Re: Zoning Commission Case No. 02-17, A Proposed One-Stage Planned Unit Development with Related Map Amendment at 5401 Western Avenue, NW – Square 1663, Lot 805 and a Portion of Lot 7

RESPONSE TO STONEBRIDGE APPLICATION
CASE # ZC 02-17
JUNE 26, 2002

LOOKING WEST ON MILITARY RD.

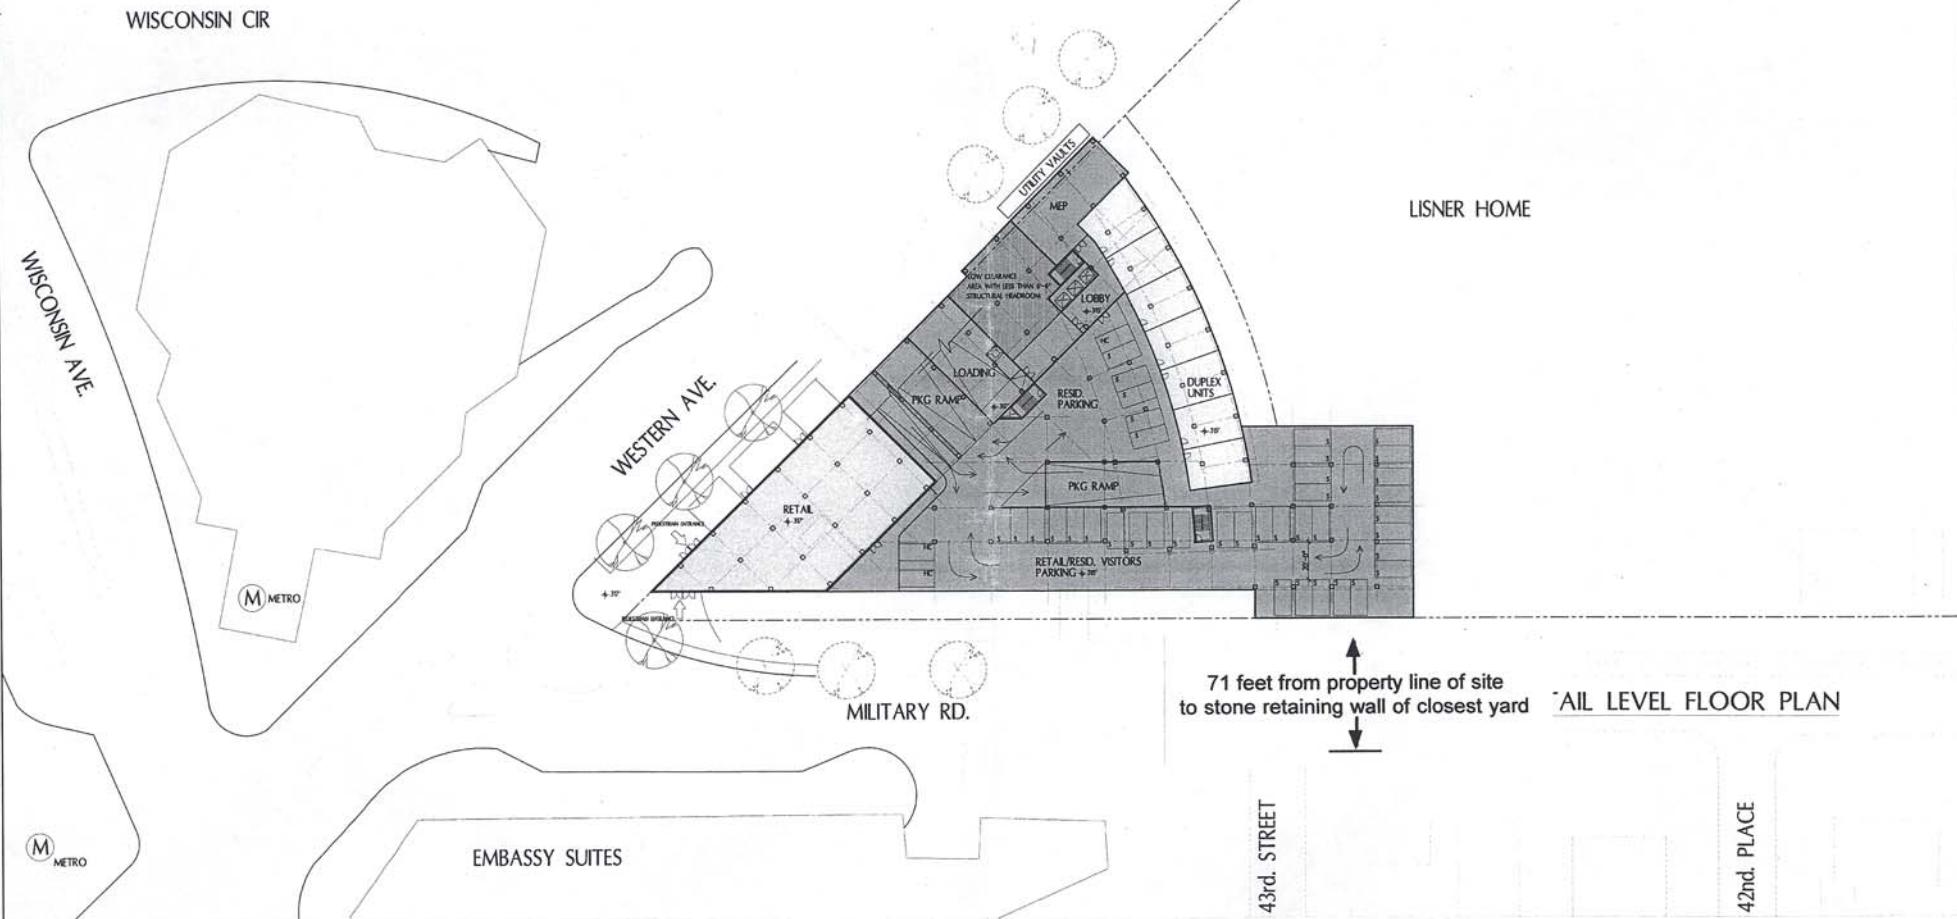
The lower drawing omits all of the single family residences on the east side of 43rd St., which are directly south of this site. Two of these houses are closer than the townhouses shown on the west side of 43rd St. All of the houses are shorter and less massive than the townhouses shown.

Also missing from the lower drawing is the higher wing of the proposed building; blue sky is shown instead. This view is similar to their M1 model photograph (photo on the right, view looking west down Military Rd.), where their entire building can be seen for comparison.

However, there is a clear illustration of the 2 story “neighborhood retail” component of the approved plan for the redeveloped Chevy Chase Center, directly across Western Ave. from this site. It shows the great depth back from Western Ave. for which a very low height (2 stories) is maintained.

EXHIBIT D

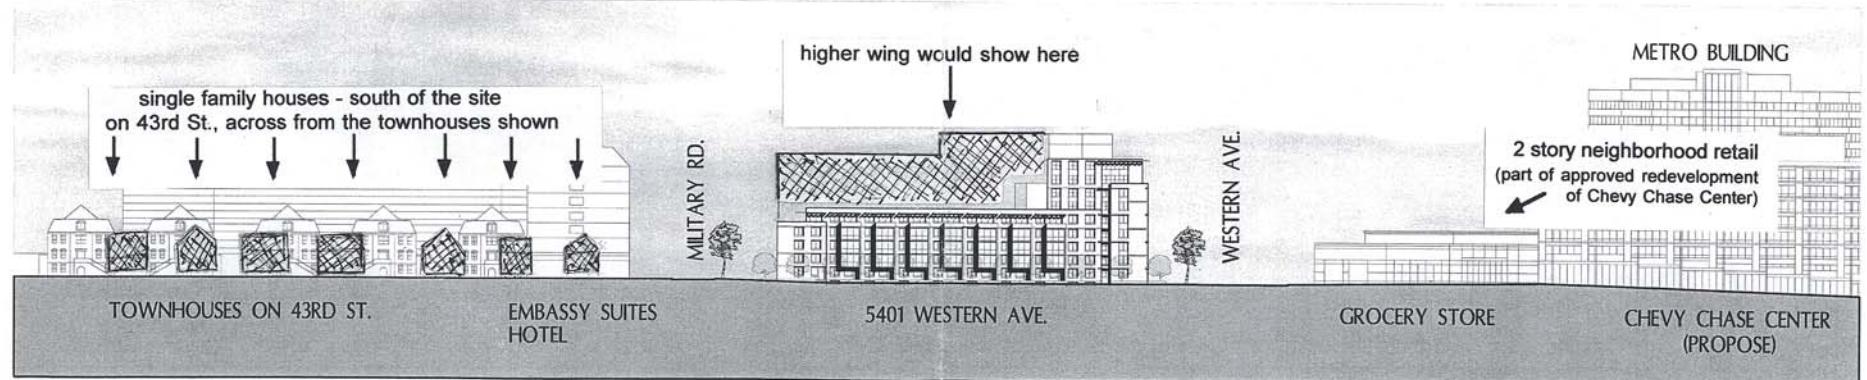
In the upper drawing, we note that the elevation of the curb at the point of Military and Western is 316', resulting in the building being 8 feet taller there, 98 feet height (roof parapet is EL 414') The mechanical penthouse is another 17'-10" higher (EL 431.83') and is flush with the building wall facing the neighborhood

In the lower drawing, again the single family houses are omitted, even though two of them are closer to this site than the townhouses that are shown.

EXHIBIT E

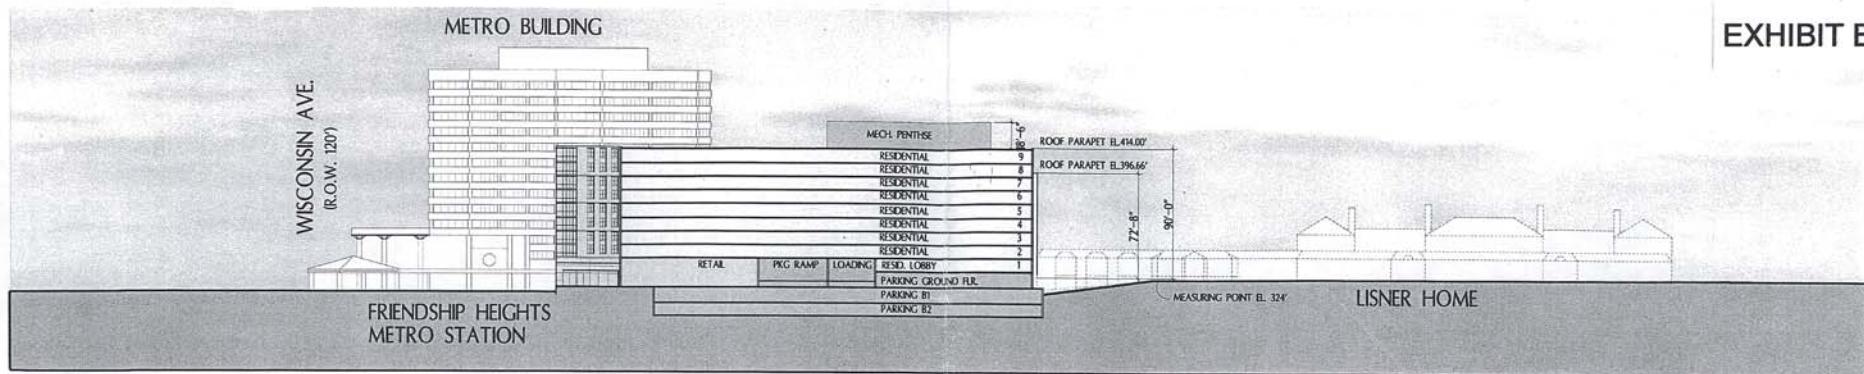
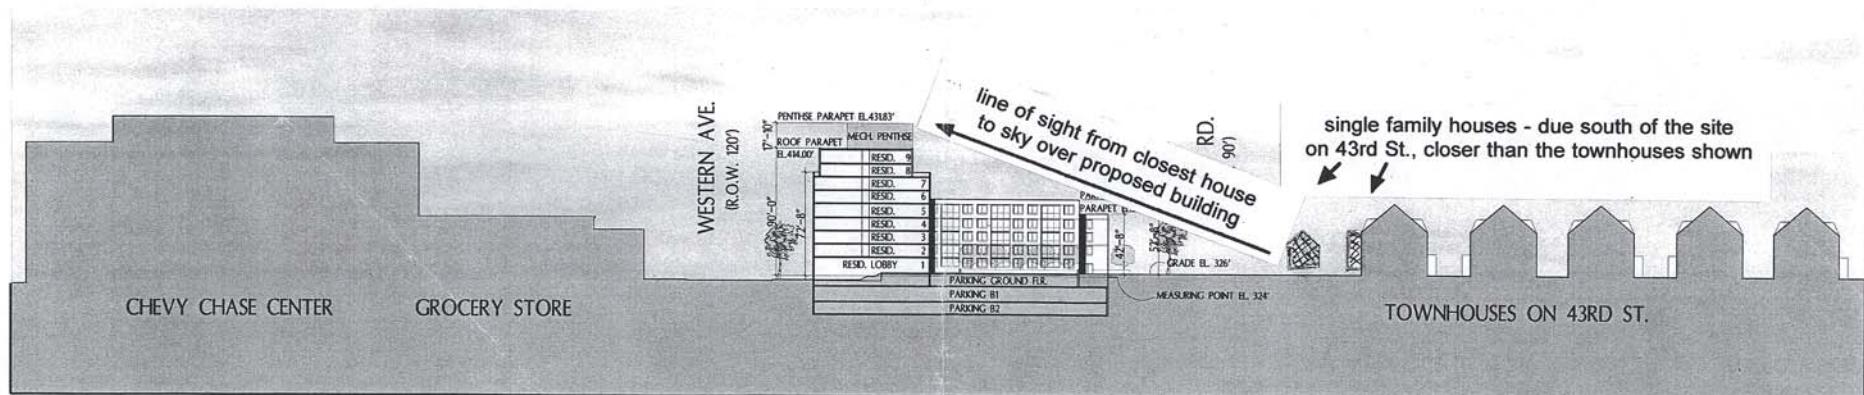
We note the line of sight that would be required for the closest neighbors to see the sky above the proposed building.
